Addendum No. 2 February 21, 2022

Twin Falls Fire Station 2

This addendum addresses the following:

The following are changes, deletions, corrections, additions, and/or modifications to the drawings, specifications, contract conditions, and bidding documents dated **January 18, 2022**. Bidding parties are required to acknowledge receipt of this addendum on the bid form. Failure to do so may subject the bidder to disqualification.

C3 HEAD DETAIL @ OVERHEAD DOORS (ALUMINUM)
A7.91 3" = 1'-0"

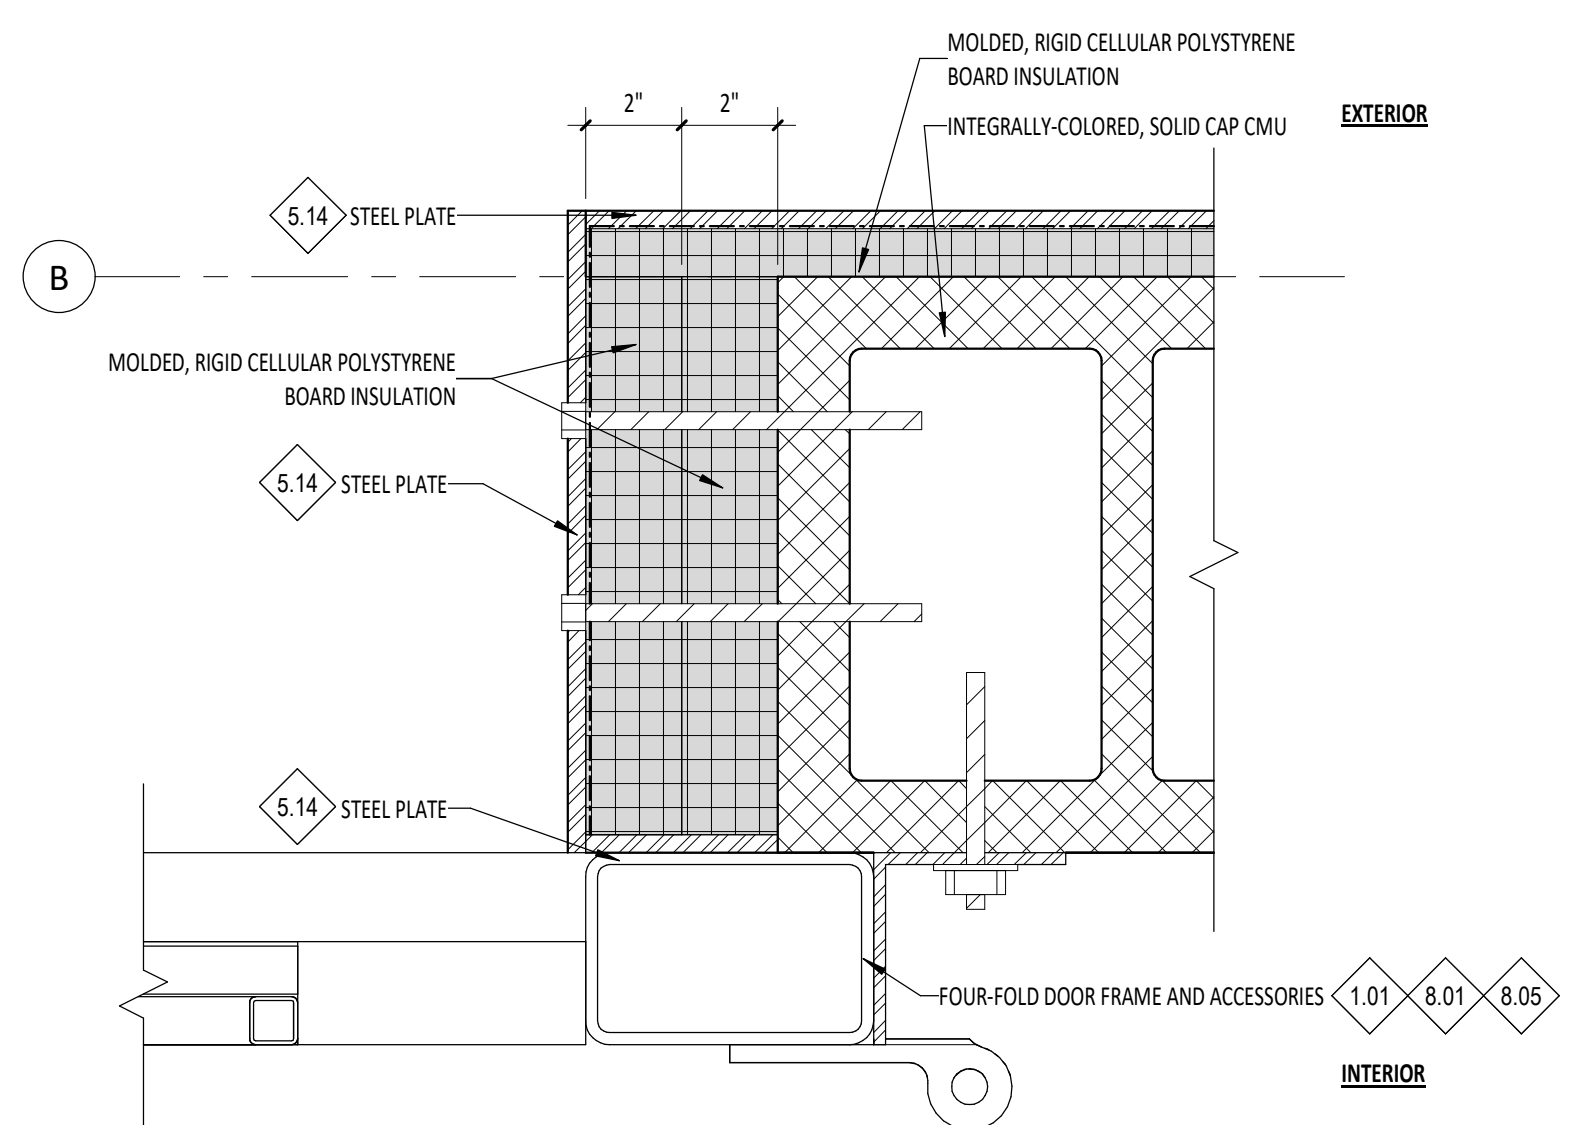
- a. REVISED detail C3 HEAD DETAIL @ OVERHEAD DOORS (ALUMINUM)
- 10. Sheet A8.01 LEVEL 1 – FINISH FLOOR PLAN AND ROOM FINISH SCHEDULE
 - a. REVISED Room Finish Schedule
- 11. Sheet A8.92 INTERIOR DETAILS
 - a. REVISED Detail D4 GRATE DETAIL AT JANITORIAL 126
 - b. REVISED Detail E4 GRATE DETAIL AT WASH ALCOVE 137

E2 LEVEL 1-COMPOSITE FLOOR PLAN
A2.01 1/8" = 1'-0"

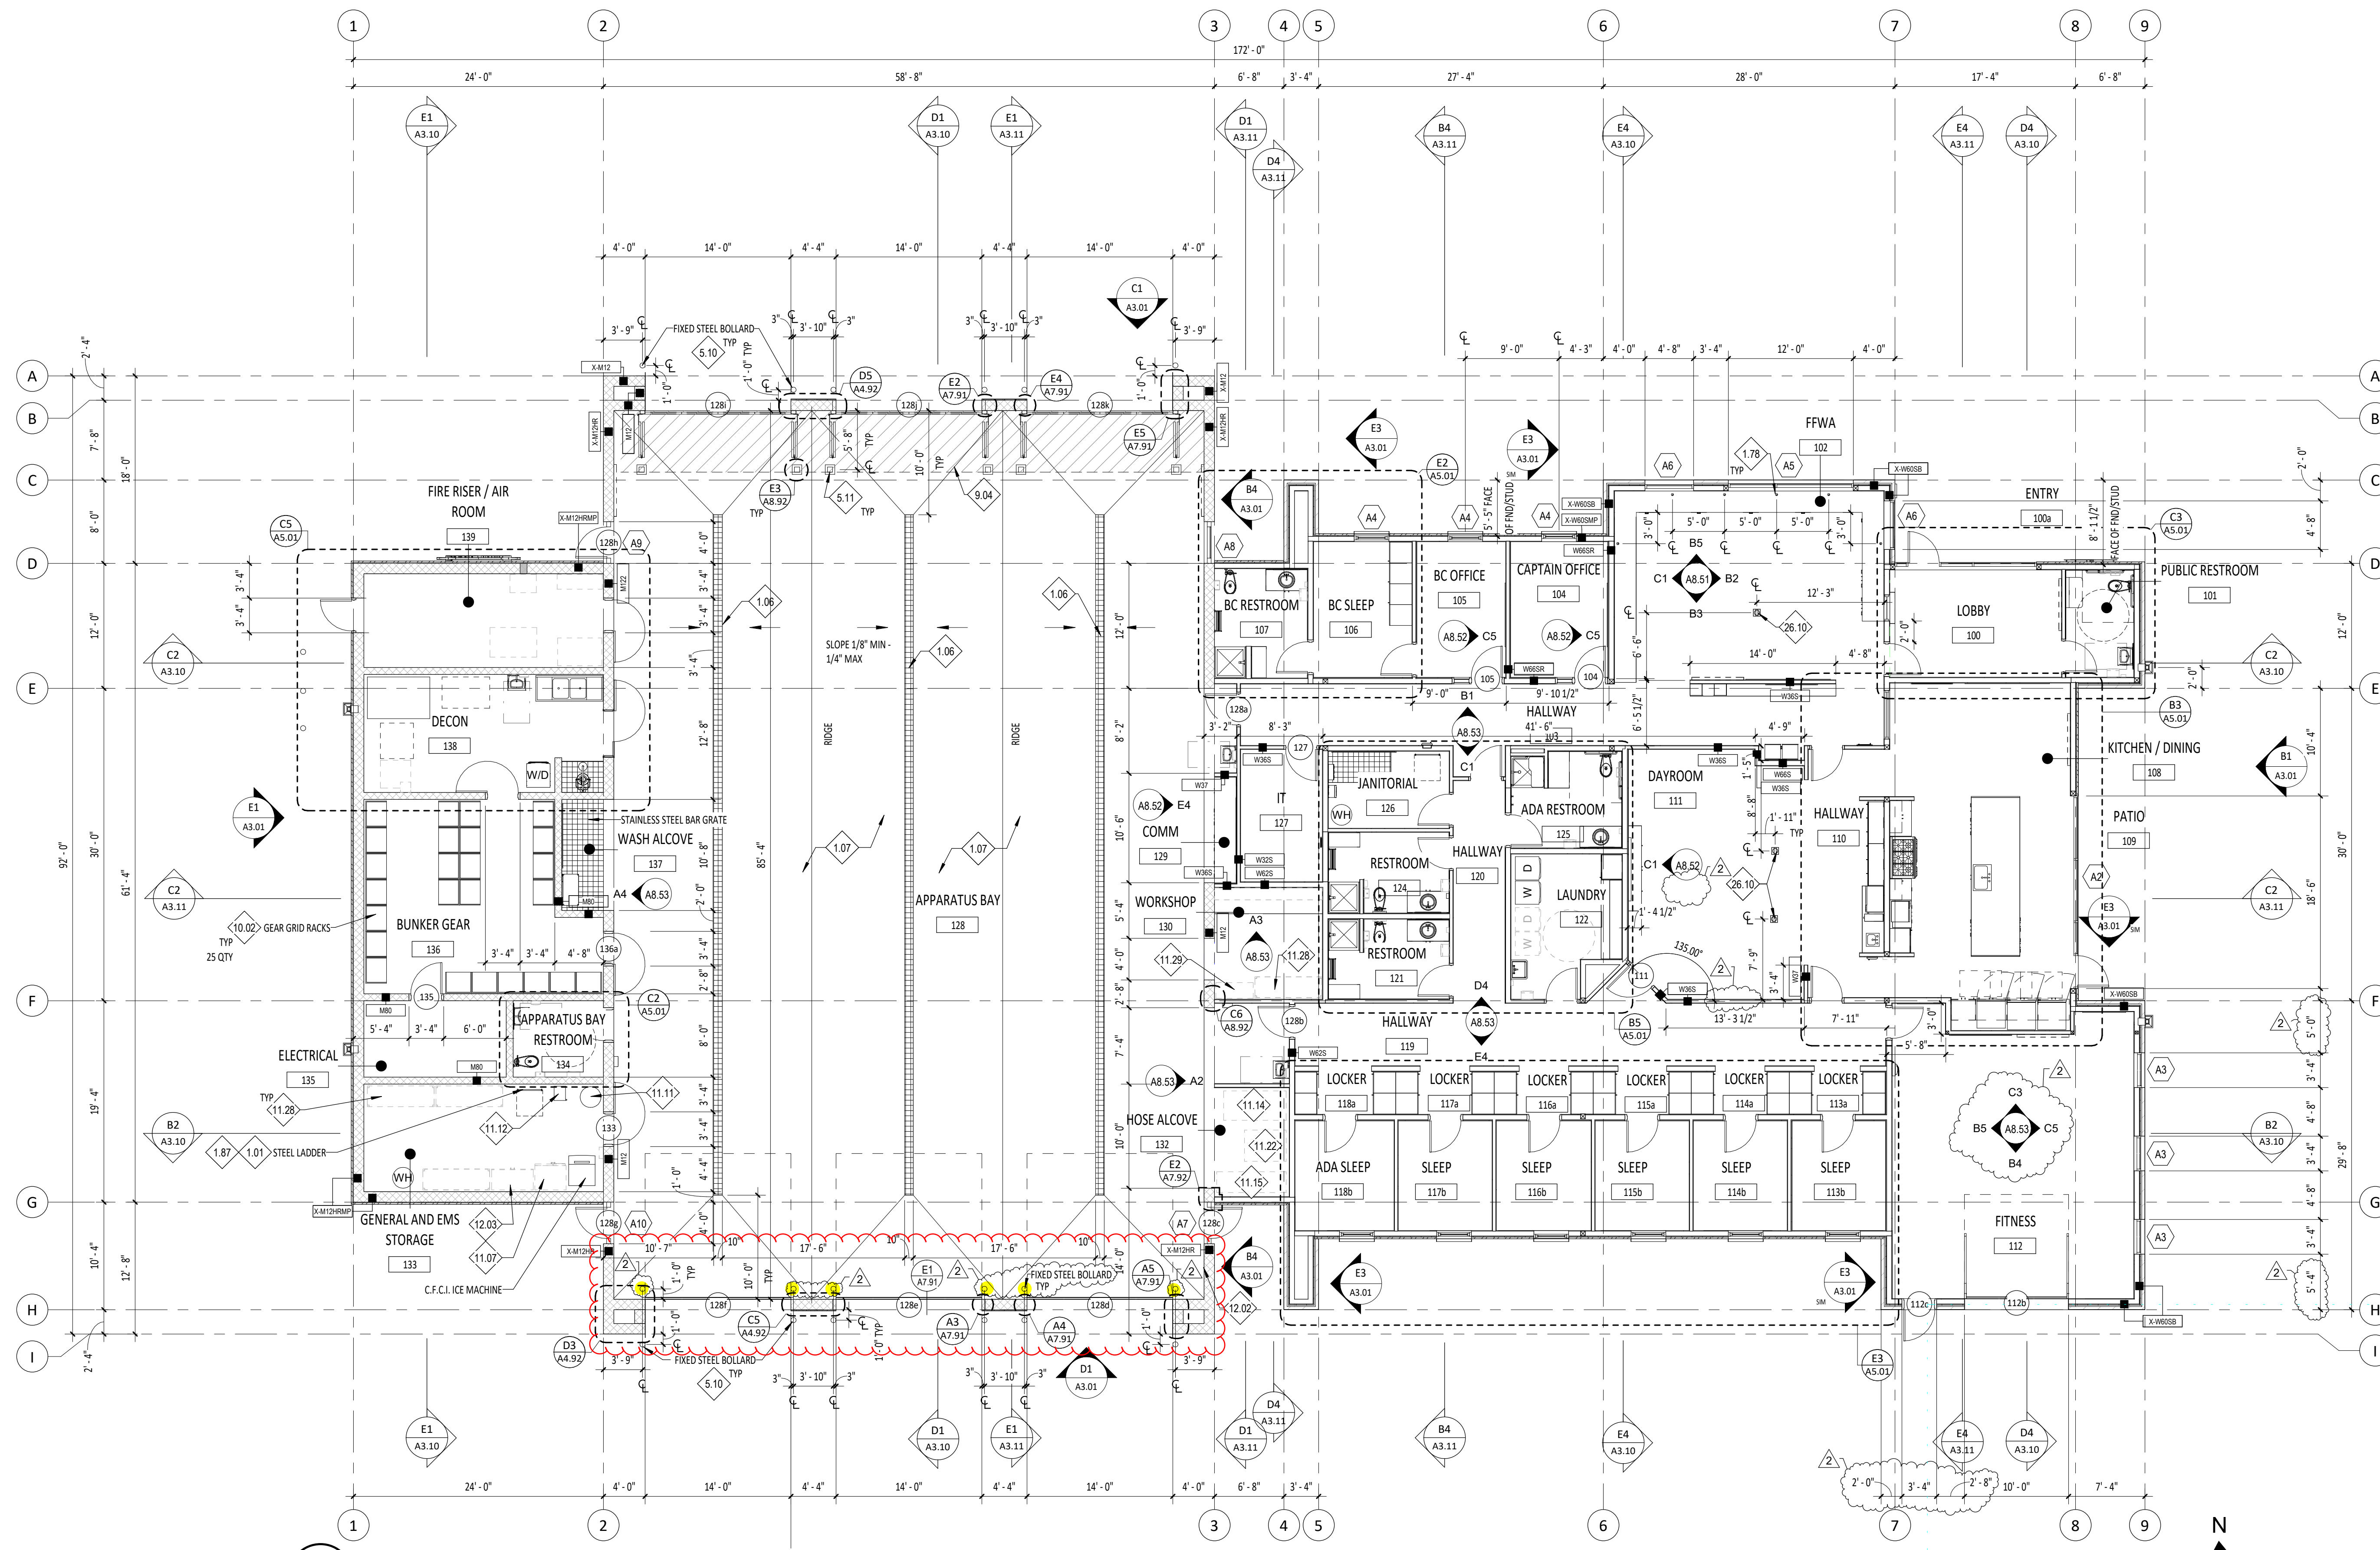
- b. ADDED Details A3 and A4.
- ◆ 4. **Sheet A2.01 LEVEL 1 – COMPOSITE FLOOR PLAN**
 - a. **ADDED (4) interior bollards to South end of Apparatus Bay**
 - b. REVISED dimensions on East and SE portion of composite floor plan.
